soft start contactors		as is
drawing by w sanders		
Date		april 3 2013
Scale		Rev

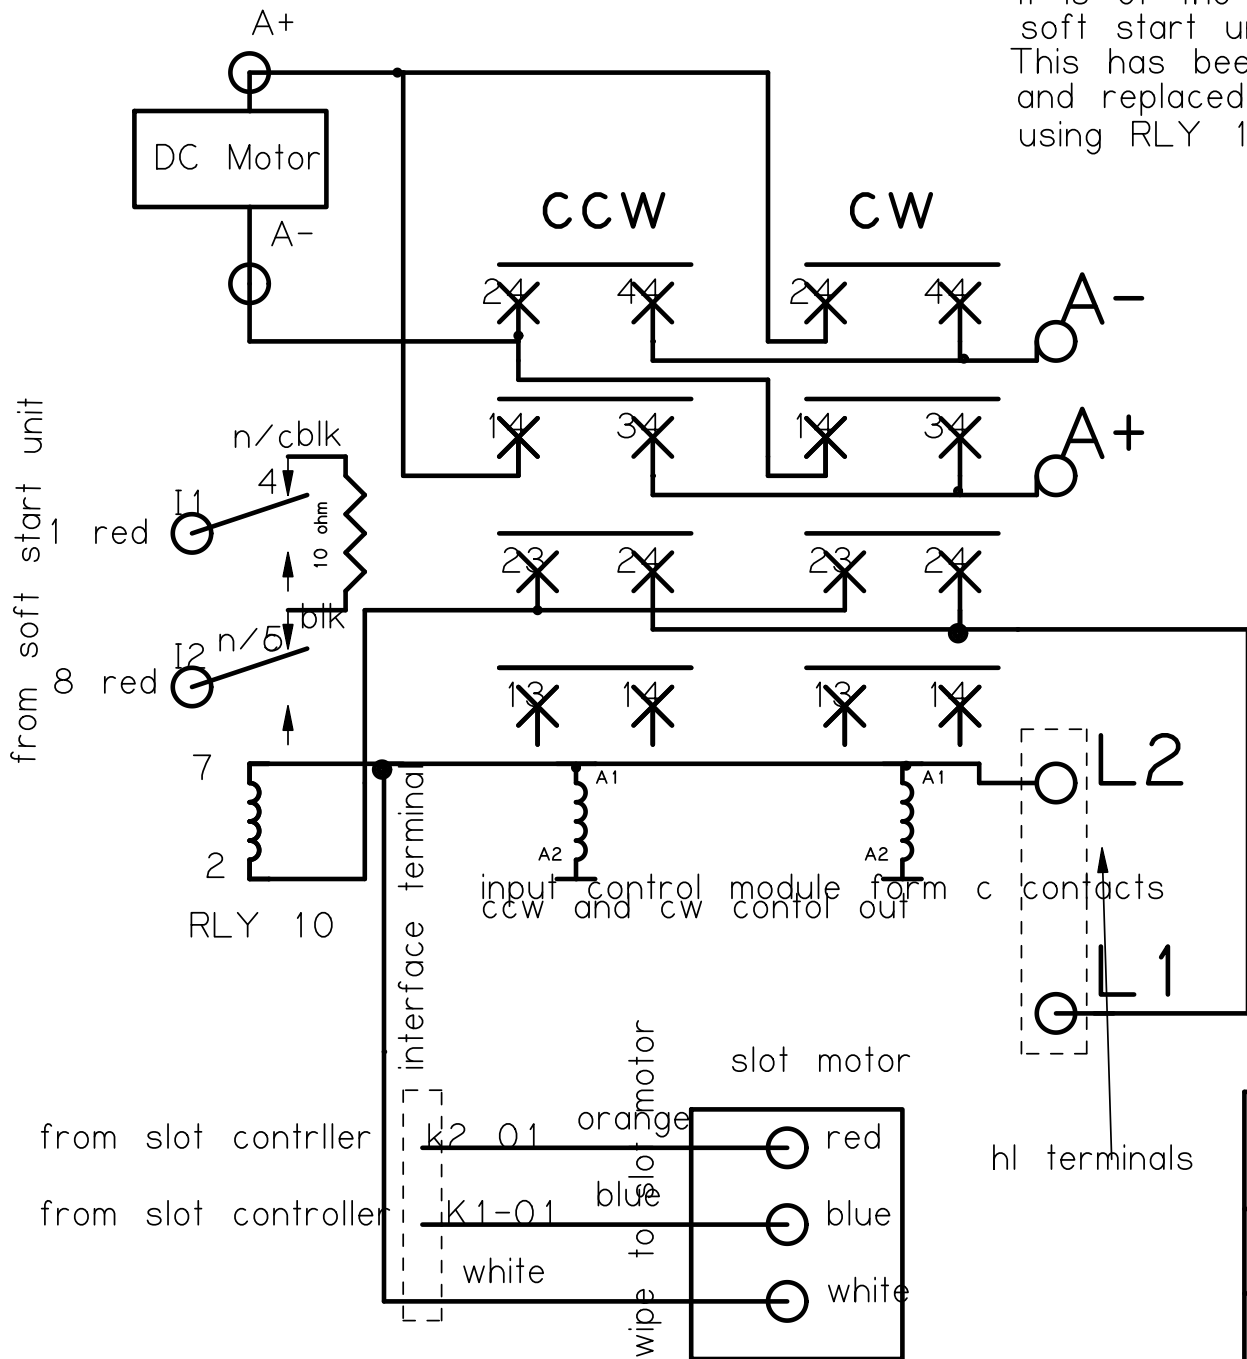
This drawing may be taken as a AS Is drawing.  
 it is of the contactor control and the marriage of the  
 soft start unit which has a rotation braking crt in it  
 This has been effectively removed from soft start unit  
 and replaced by same type crt in contactor box  
 using RLY 10
